98-20, *Publication Date: SEPTEMBER 29, 1998*

<ul style="list-style-type: none"><li>• <b>Exhaust System - Loose Catalyst Or Muffler Heat Shields</b></li><li>• <b>Noise - "Buzzing" Or "Rattling" - Loose Catalyst Or Muffler Heat Shields</b></li></ul>	<b>Article No. 98-20-10</b>
--	---------------------------------

Figure 1 - Article 98-20-10

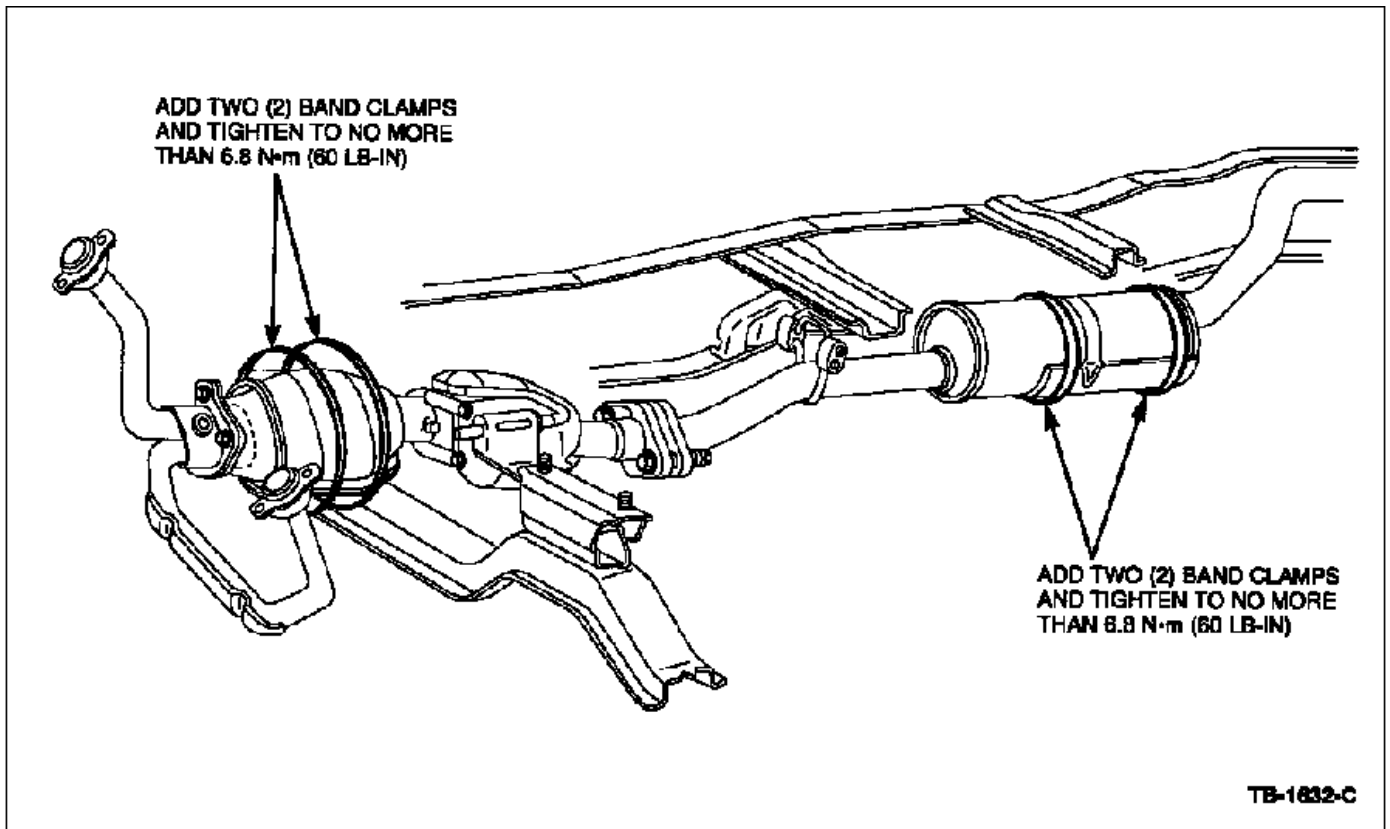
2. Install worm clamps to the catalytic converter, catalytic pipes, muffler pipes or muffler as shown in Figure 1 for the typical light truck and Figure 2 for the typical passenger car.

3. Align the clamps to secure the heat shield to the catalytic converter, catalytic pipes, muffler pipes or

muffler as required.

4. Tighten the clamps to 6.8 N-m (60 lb-in).
5. Trim the excess "ear" of the clamp to approximately 2.54 cm (1").
